#### **REMARKS**

Michael D. Gerdes Page 1 of 1
Improved Vehicle Component Centering
System for Vehicle Service Devices
Mark E. Books, Reg. No. 40,918 - HE 8698US
Replacement Drawing (marked to show changes)

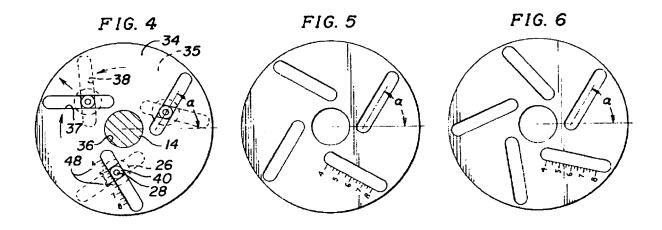
The Examiner has objected to the drawings under 37 CFR 1.83(a) as failing to show every feature of the invention specified in the claims. Specifically, the Examiner has stated that identifying indicia associated with each of the slots (i.e., "color, numbers, letters, or surface relief, as detailed in the specification) must be shown or the features cancelled from the claims. These features are set forth only in Claim 25.

The drawings have been amended such that an identifying indicia associated with the illustrated slots is shown. Specifically, identifying indicia in the form of numbers corresponding to subsets of slots (i.e. 3, 4, 5, and 7) have been added to Figures 7A and 7B where appropriate to identify slots comprising each subset. A clean set of the amended drawings and a marked up set illustrating the changes made have been provided. The use of numbers to identify subsets of slots is clearly described at Para. [0050] of the Specification, so the addition thereof to Figures 7A and 7B is not an entry of new matter.

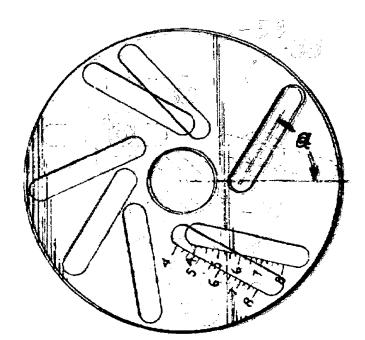
A replacement of the individual mounting flange plates disclosed by the '128 *Mitchell* reference with the singular plate disclosed by the '911 *Warkotsch* reference, as suggested by the Examiner, would clearly result in a completely non-functional system. An illustration of what such a combined singlular flange plate might look like, if using the designs shown in the '128 *Mitchell* reference, may be made by overlapping Figures 4,

5, and 6 of the '128 Mitchell reference as shown herein. As is clearly visible in this illustration, the tangential slot configurations of the '128 Mitchell reference, which are required to accommodate different lug patterns, cannot be combined on a single mounting flange, as slots for the different lug hole patterns would

intersect each other. Furthermore, the intended design of the '128 Mitchell reference, which requires that the underlying adjusting plate have corresponding slots which are

aligned perpendicular with the slots in the mounting flange plate, would have similar problems with intersecting slots, precluding the ability to radially move unobstructed passages (for mounting pins) to accommodate different diameter lug patterns by rotating the adjusting plate relative to the mounting flange plate.
